Response to Submissions SSD 6674 Environmental Impact Statement

The University of New South Wales

Biological Sciences Project

Submitted to Department of Planning and Environment
On Behalf of University of New South Wales

Figure 1 – Connectivity Diagram
Source: Woods Bagot

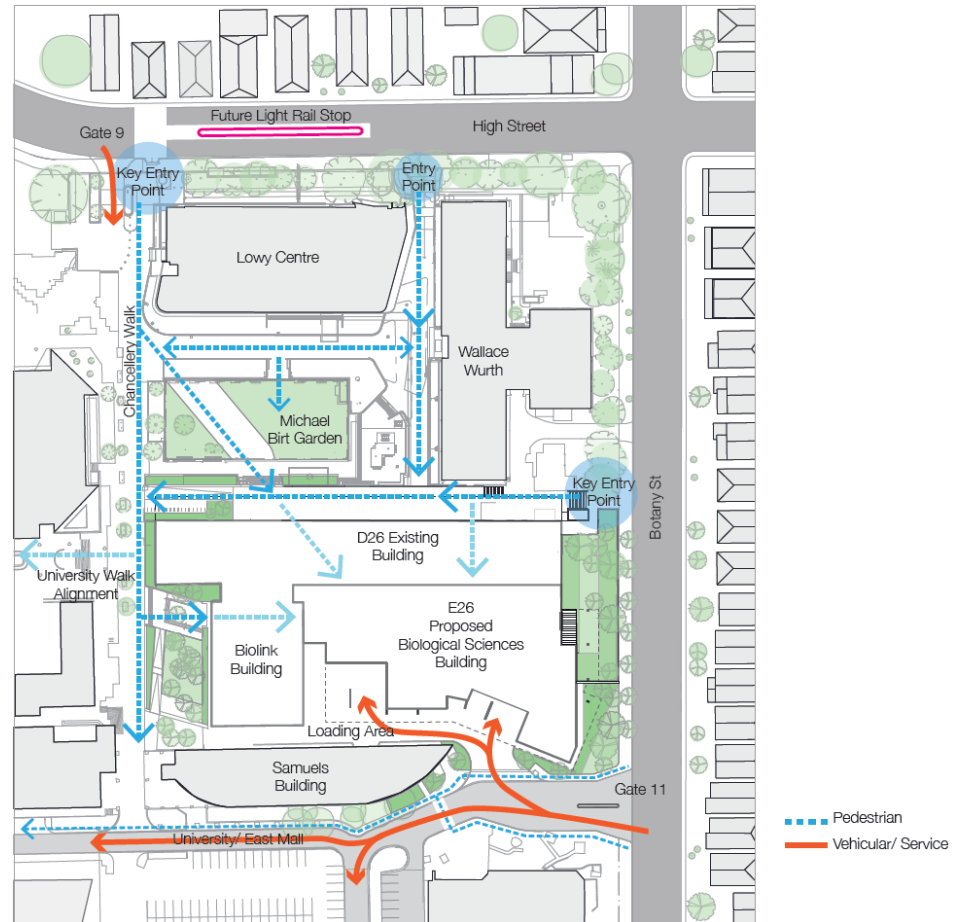
The DPE have requested further consideration should be given to the activation of the south eastern corner of the site or the treatment of this façade to provide an improved visual setting given Gate 11 is a designated entrance/exit to the campus and the eastern end of University Mall.

Figure 1 responds to Council's comments that further consideration should be given to opportunities to improve pedestrian and cycle links through the site, and connection to major pedestrian thoroughfares.

The scheme aims to separate vehicular and pedestrian access and encourage pedestrian access away from Gate 11, preserving car-free access along Chancellery Walk and Michael Birt Garden to the north.

As shown in **Figure 1** below, in order to discourage pedestrian access via Gate 11 and subsequently along Library Road, the key entry point to the site and precinct is proposed from Botany Street via the existing space between the Wallace Wurth building and the existing D26 building. With the future South East Light Rail station planned on High Street, the large majority of students accessing the upper Campus will be from Gate 9 along Chancellery Road and through Michael Birt garden.

Figure 3 – Travel trends, 2007 - 2015

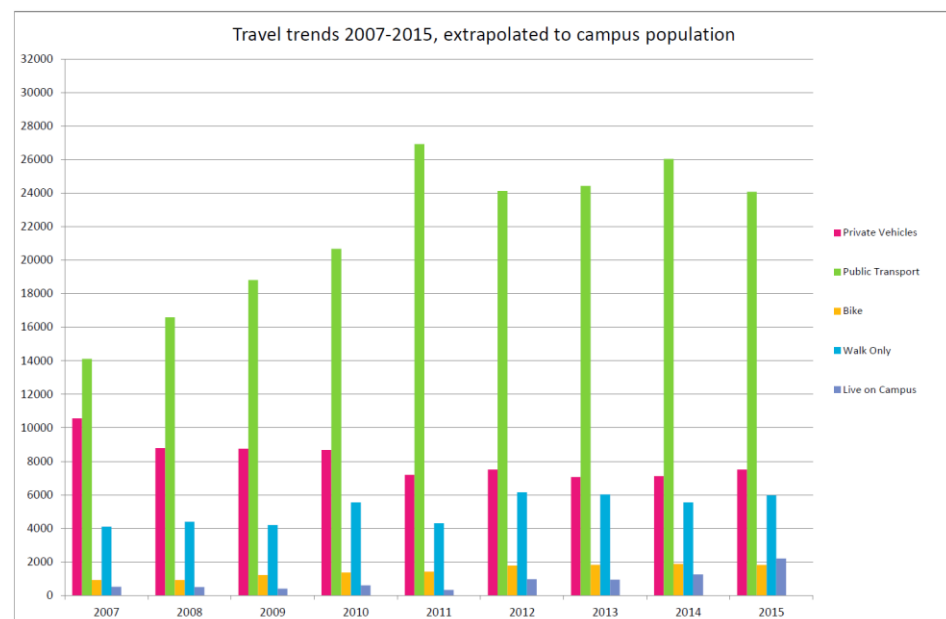
Following on from their concerns over the building population (staff and student) numbers, the DPE have request the application provide further assessment of the traffic and transport impacts associated with the potential increased staff and student numbers based on building capacity. Additionally, the DPE have requested that details of travel demand management measures that have been implemented at the University, and the effectiveness of these measures be provided.

Extrapolating the data from UNSW Travel Surveys (2007-2015), trends suggest that in 2018 only 13 parking spaces will be required in order to meet the additional staff demand. This is based on the following:

- 91% of all staff attend the campus daily.
- Trends suggest that only 31% of staff will drive.
- Trends suggest that only 76% of the staff who drive will park on Campus in 2018.
- At the peak period (11am), only 60% of staff were present on Campus.

Applying the mode share percentage to the additional staff (95), results in a total of 35 additional cars. Calculation of parking demand requirement in accordance with 60% of staff attending the Campus at the 11am peak period (in accordance with the DCP Transportation Strategy – Figure 5.12) results in a demand of 21 car parking spaces. With a continuation of the ongoing trend in reducing car use, this number will drop to 16 spaces in 2018 when the building is anticipated to open.

Figure 4 – Parking Permit Trends, 2007-2015

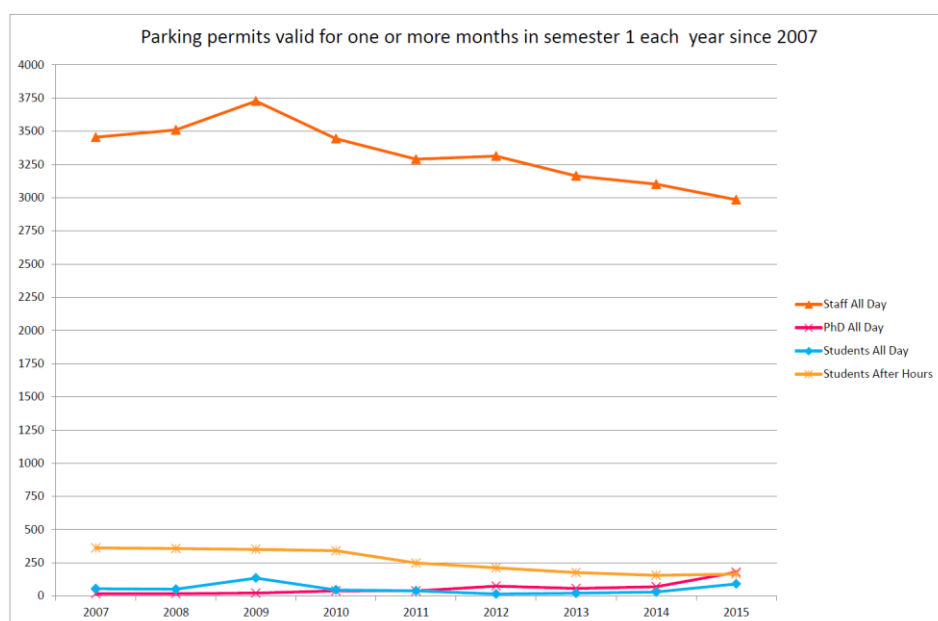
Council has also raised concerned over the cumulative impact developments on campus in recent years that have provided no parking, and the high probability that over time the total number of car parking spaces on campus has reduced while the numbers of staff and students continues to increase.

The reducing trend in private car use is also supported by a reduction in the number of parking permits being issued on campus since 2007 as demonstrated in **Figure 4**.

Figure 6 – Figure 5.6a of Randwick Council DCP 2013
 Source: Randwick City Council and Black Beetle

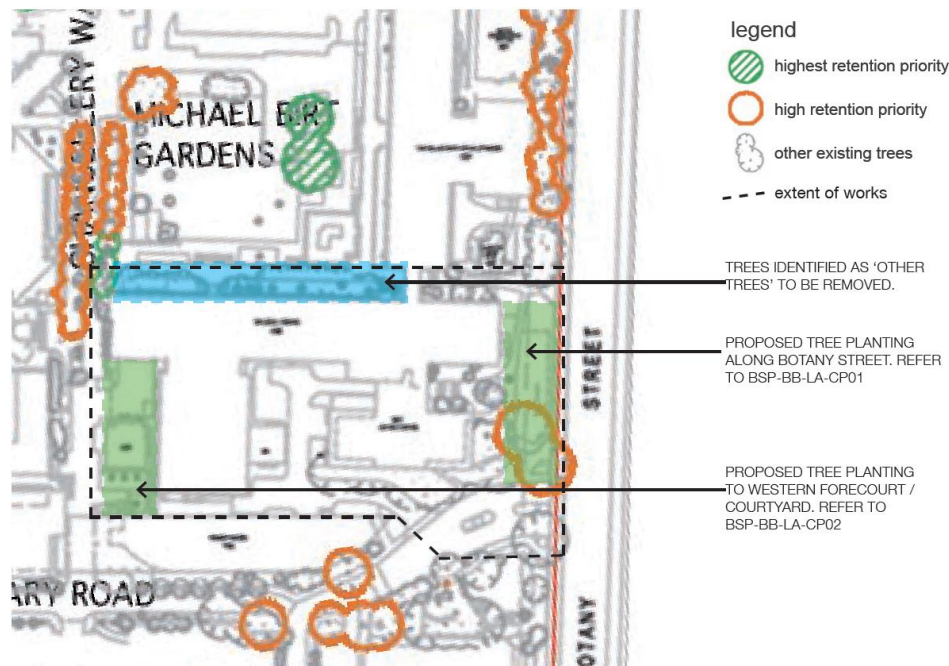
In their submission, Council have requested that the proponent consider the importance of soft landscaping elements adjacent to Michael Birt Gardens and the Chancellery Walk. They have also requested that possible options in which landscaping can be provided towards the northern edge or provide any agreed replacement of trees or compensation strategies be considered. Council also appears to be uncertain as to the trees that are proposed to be removed on the northern side of the site.

The proposed selection of palms (*Livistona australis*) to the western courtyard, adjacent Chancellery Walk provides a continuation of the existing palms (highlighted as 'high retention priority' in figure 5.6a) – see **Figure 6**. It also provides an opportunity to establish a significant grove of palms along the Chancellery Walk. Importantly, the proposal does not erode or affect the existing pedestrian pathway or sight lines along Chancellery Walk. Similarly, the proposed landscaping does not impact on the eligibility of the western entry to the building, but rather provides identification and 'markers' of the building entrance in this location

For clarity, the trees identified as 'highest retention priority' and 'high retention priority' within Michael Birt garden as per the Randwick DCP 2013 (Figure 5.6a) will be retained as part of the proposed development, and will not be impacted.

The trees proposed to be removed are identified as 'other trees', as shown below in **Figure 6**. The Landscape statement notes that the majority of the trees in this location are considered as invasive environmental weeds.

Figure 7 – Proposed Gate 11 landscape treatment

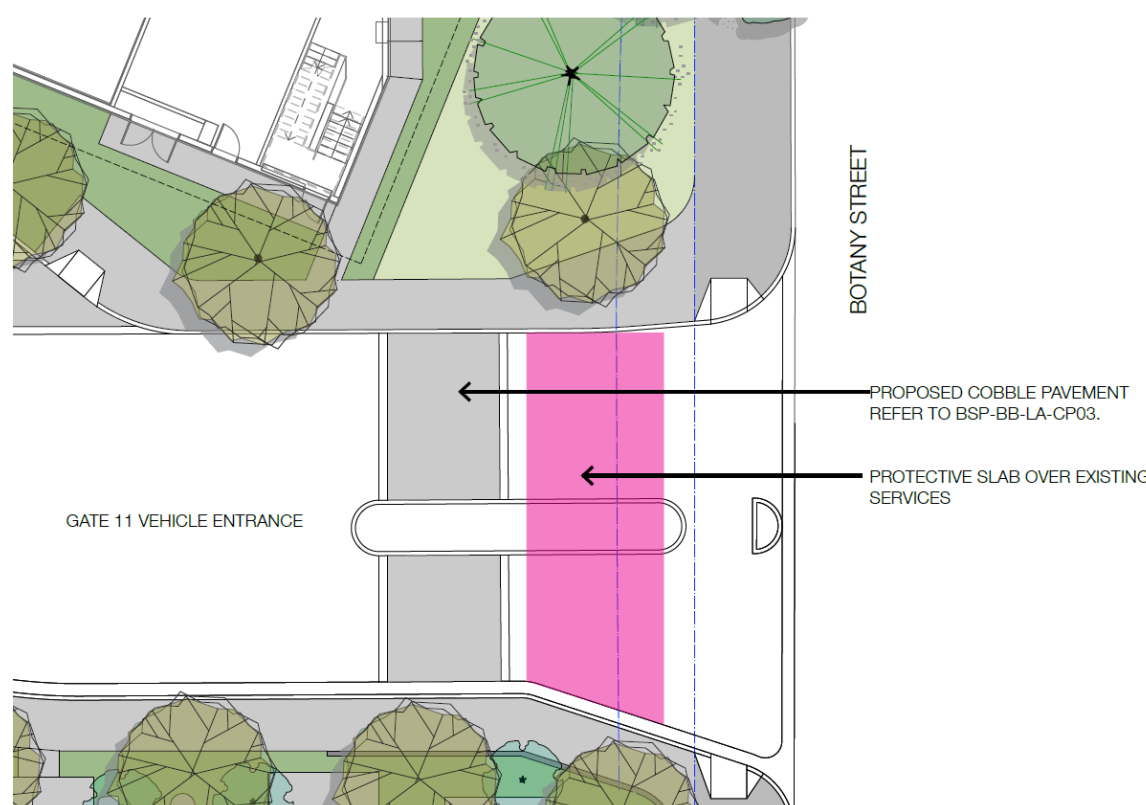
Finally, Council has raised concern over the legibility of building, in particular the western entry to the site from the Chancellery Walk. It has also been recommended that differentiated threshold treatment at Gate 11 is introduced in order to not read as a public road going through the campus, and to provide a continuous and safe pedestrian footpath.

A differentiated paving and threshold treatment of cobbles has been proposed as part of the Gate 11 enabling works to replicate the cobbled pavement at the existing Gate 11. The location of this crossover is restricted by below ground services in the zone directly adjacent Botany Street. The arrangement, along with University sign posting will contribute to the entry not reading as a public road. The proposed arrangement, designed in accordance with Council road design requirements, also provide continuous paths of travel for pedestrians travelling north/south along the western side of Botany Street as shown below in **Figure 7**.
